Access Compliance Report Public Rights-of-Way (Pedestrian Signals)

Main Street: O NEILL_DR Cross Street: O NEILL_DR Location: NE

ADA ID: SGRK211026131650 Signal Type: One Push Button-Non APS Overall Compliance: No Severity Scores: BTN 1: 35 BTN 2: N/A No BTN: N/A

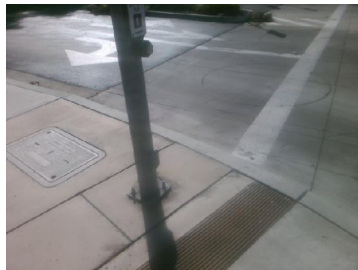
OC Std/PROW: R404.2, MUTCD 4e.08

Possible Solutions: Replace Signal Push Button With APS Button. Remove and Replace Clear Space.
